SUBJECT: BROWNS FERRY NUCLEAR PLANT, UNIT 2 - ISSUANCE OF AMENDMENT
REVISING PRESSURE AND TEMPERATURE LIMIT CURVES (TAC NO. MF4303)

Amendment No. 314
Renewed License No. DPR-52

SAFETY EVALUATION BY THE OFFICE OF NUCLEAR REACTOR REGULATION

**Figure 3.4.9-1
Pressure/Temperature Limits for
Mechanical Heatup, Cooldown following Shutdown, and
Reactor Critical Operations**

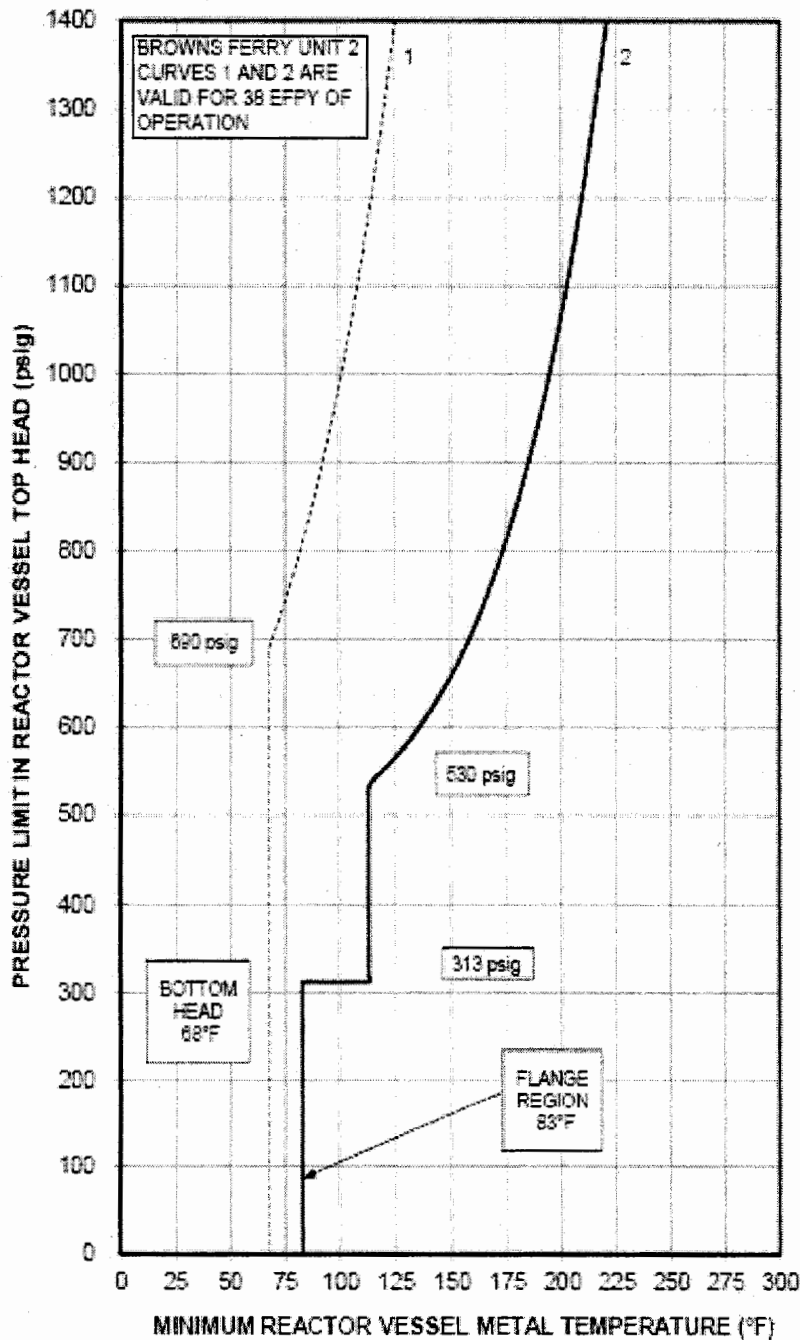
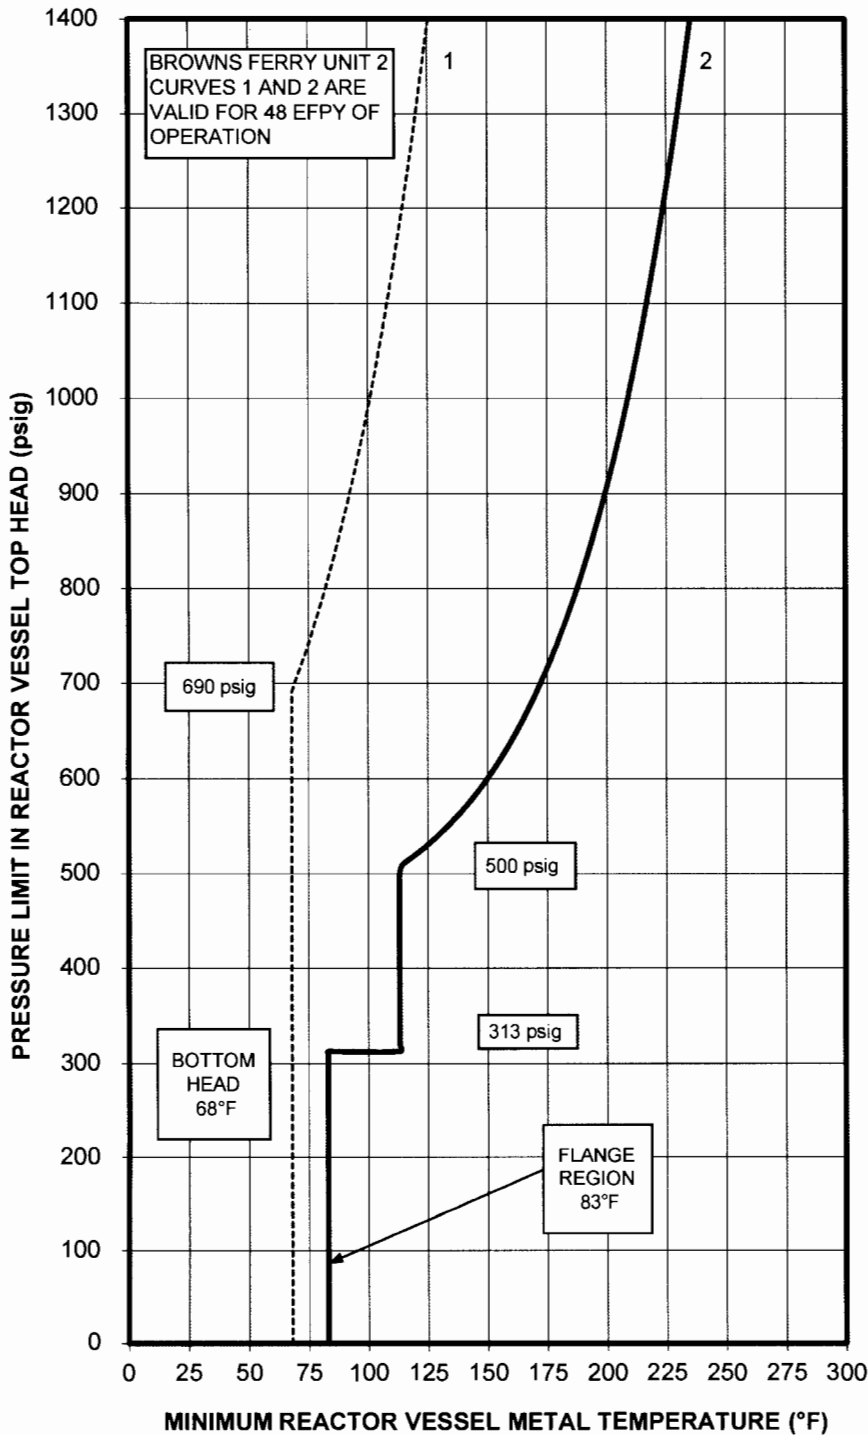
These curves include sufficient margin to provide protection against feedwater nozzle degradation. The curves allow for shifts in RT_{NDT} of the Reactor vessel beltline materials, in accordance with Reg. Guide 1.99, Rev. 2, to compensate for radiation embrittlement for 38 EFPY.

Notes
These curves include sufficient margin to provide protection against feedwater nozzle degradation. The curves allow for shifts in RT_{NDT} of the Reactor vessel beltline materials, in accordance with Reg. Guide 1.99, Rev. 2, to compensate for radiation embrittlement for 48 EFY.

The licensee provided composite and limiting P/T limit Curves A, B, and C. The composite curves are consistent with composite curves generated independently by the NRC staff applying the GE methodology, shifting the approved generic GE curves by the ART for the limiting material identified. For all conditions, the Appendix G to 10 CFR Part 50 requirements for the minimum metal temperature of the closure head flange and vessel flange regions produce limiting "notches," serving to explain the distinct vertical lines at constant temperature above ~313 psig in the licensee's proposed P/T limits. The licensee had updated the hydro test pressure from 312 to 313 psig based on its Form N-1A Manufacturers Data Report for Nuclear Vessels. For all BFN-2 curves, a minimum temperature of 68 °F for the bottom head and 83 °F for the flange region was verified as being ASME Code-compliant per the stipulation that these regions must be at least $RT_{NDT} + 60$ °F (where RT_{NDT} represents that property of the limiting material in the relevant region). When $P > 313$ psig, the minimum temperature of 113 °F for the pressure test curve, 143 °F for the normal operation/core not critical curve, and 214.6 °F for the normal operation/core critical curve were not all derived from adding 90 °F, 120 °F, and 160 °F to the RT_{NDT} of 23 °F for the limiting flange material as specified in Appendix G to 10 CFR Part 50 for the three operation conditions. The NRC staff requested that the licensee clarify how these values were calculated, and the licensee provided the calculations in its December 2, 2014, letter. The licensee indicated that the 214.6 °F value for the normal operation/core critical curve was derived from the minimum permissible temperature for inservice system hydrostatic pressure testing consistent with 10 CFR 50, Appendix G, requirements.

Based on the above evaluation, the NRC staff determined that the licensee's proposed P/T limits are in accordance with the NEDC-33178-A GE methodology and satisfy the requirements of Appendix G to Section XI of the ASME Code and Appendix G to 10 CFR Part 50. Hence, the licensee's proposed P/T limit curves are acceptable.

**Figure 3.4.9-2
Pressure/Temperature Limits for
Reactor In-Service Leak and Hydrostatic Testing**

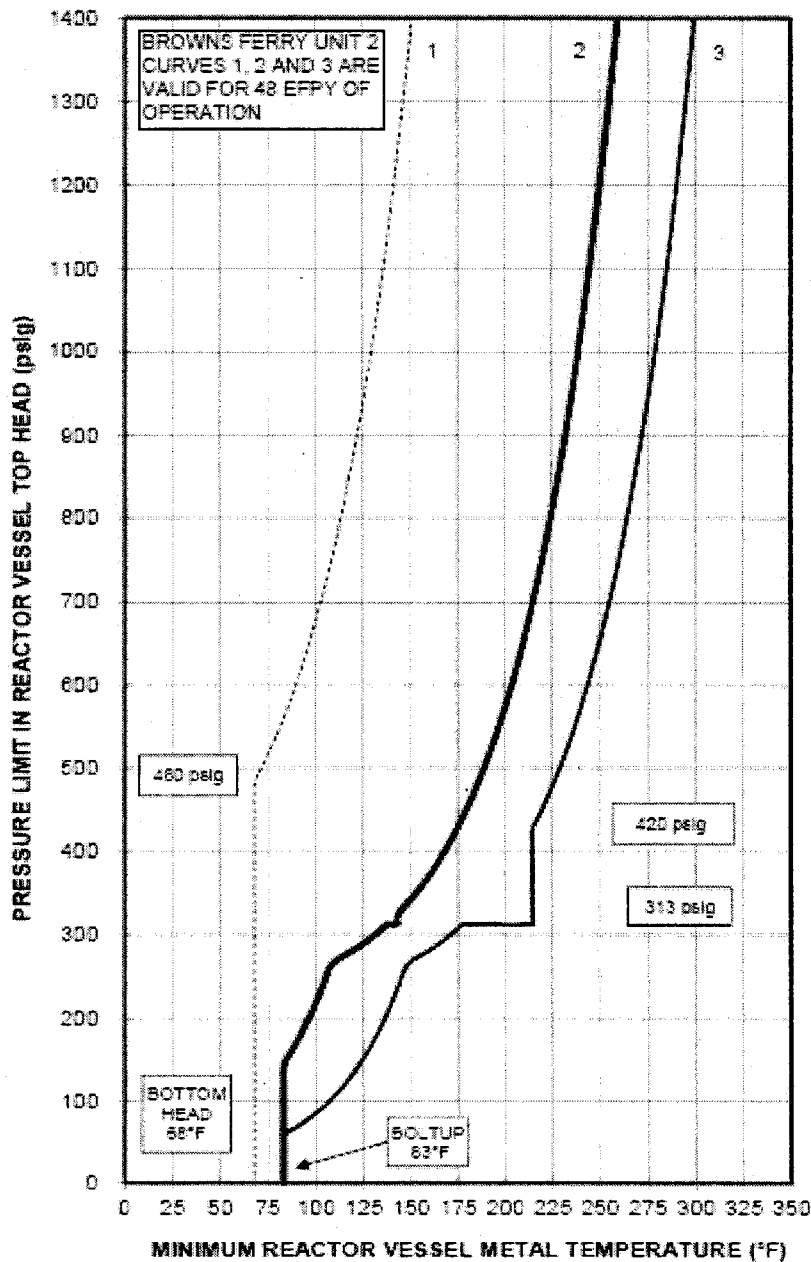
Notes
These curves include sufficient margin to provide protection against feedwater nozzle degradation. The curves allow for shifts in RT_{NDT} of the Reactor vessel beltline materials, in accordance with Reg. Guide 1.99, Rev. 2, to compensate for radiation embrittlement for 38 EFPY.

Notes
These curves include sufficient margin to provide protection against feedwater nozzle degradation. The curves allow for shifts in RT_{NDT} of the Reactor vessel beltline materials, in accordance with Reg. Guide 1.99, Rev. 2, to compensate for radiation embrittlement for 48 EFY.
